Pakiza Knit Composite Ltd. (New Building)

A-1/5, Mojidpur (Boro-bolimeher), Savar, Dhaka 1340
(23.842333, 90.259173)

5th January 2020 & 19th January 2020

Observations

Column Layout

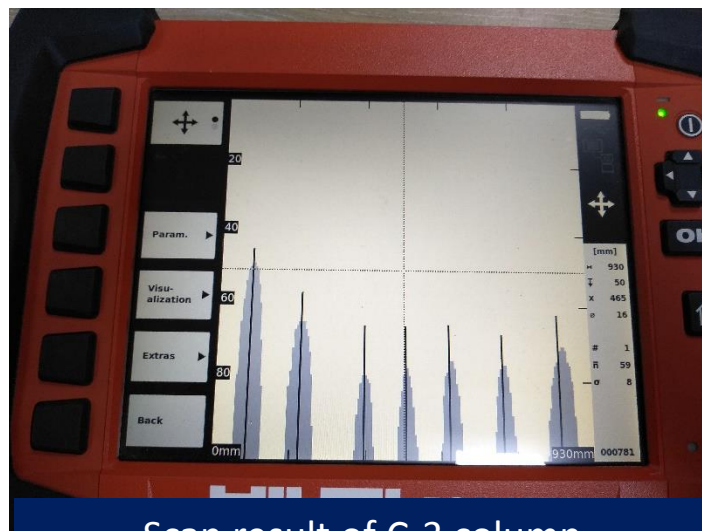
Number of rebar in C-3 type column didn't match with column schedule. In C-3 column 7 rebars were counted by ferro scanning in one direction instead of 9 rebars.

Stacked of construction materials

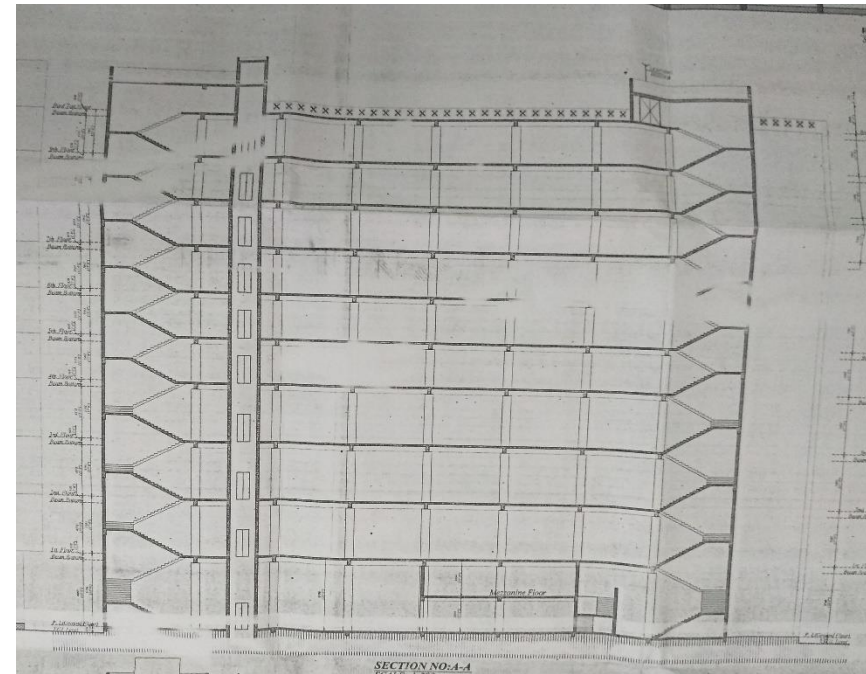
Corrosion was observed on some exposed reinforcement on roof. Factory must provide adequate protection to the structural elements from corrosion.

Local authority Permit drawing shown 10 storied

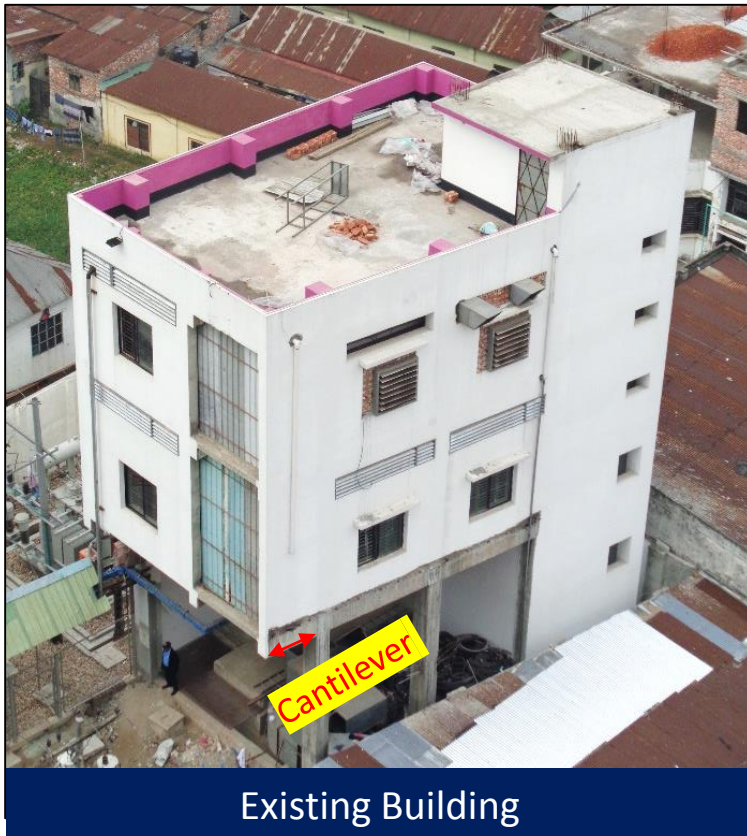
This building is permitted for 10 (G+9) storied from local authority. Currently the building is partially 8 storied. Factory owner has a future plan to extend the building. Factory engineer is required to carry out a Detail Engineering Assessment considering BNBC provision prior to any extension work.

Existing Building

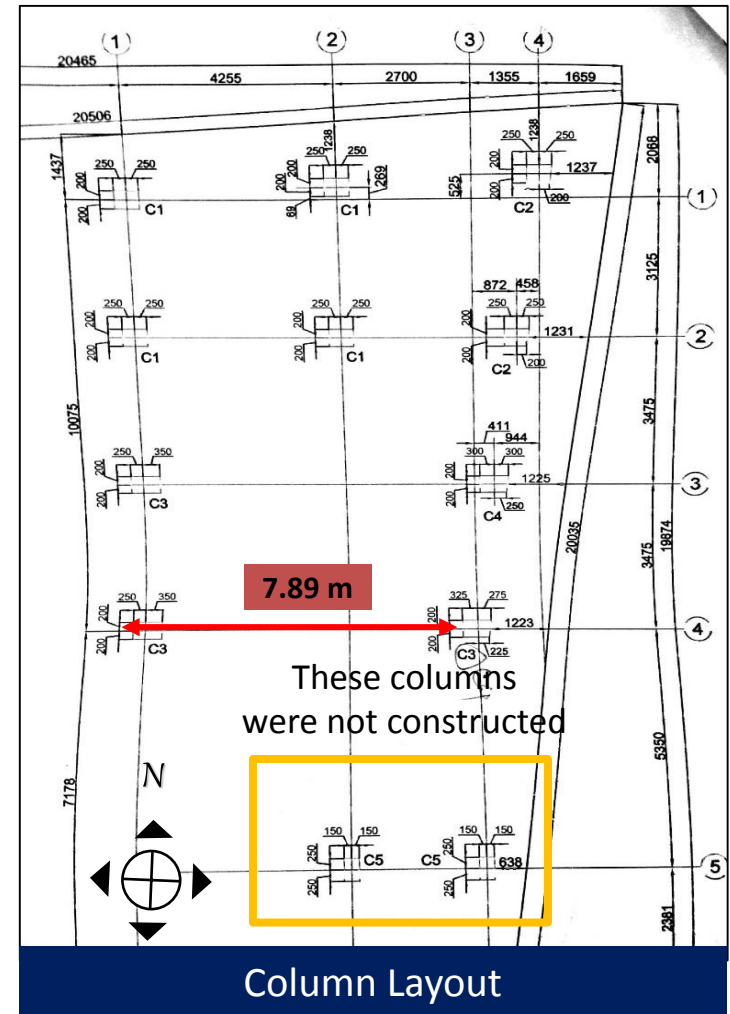
The building columns arranged irregularly. The ground floor height is long and the bays are large having infill walls. Also, a portion of the building has not been constructed yet. The factory engineer to review the design of the existing building for lateral forces.

Please undertake a specific check on the moment resisting frames to ensure that they can resist the applied lateral load with sufficient FoS.

Possible Horizontal Extension

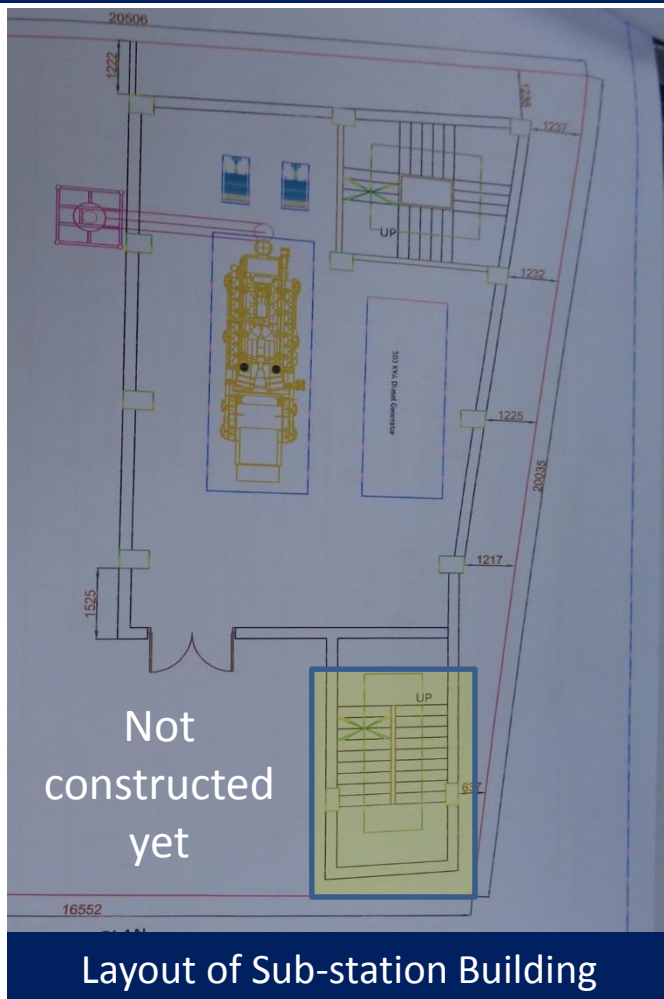
A set of proposed drawings has been provided for Sub-station building. Also, Grade beam reinforcements are found exposed at South side of the structures. Factory owner has a future plan to extend the building horizontally. Factory engineer is required to carry out a Detail Engineering Assessment considering BNBC provision prior to any further extension work.
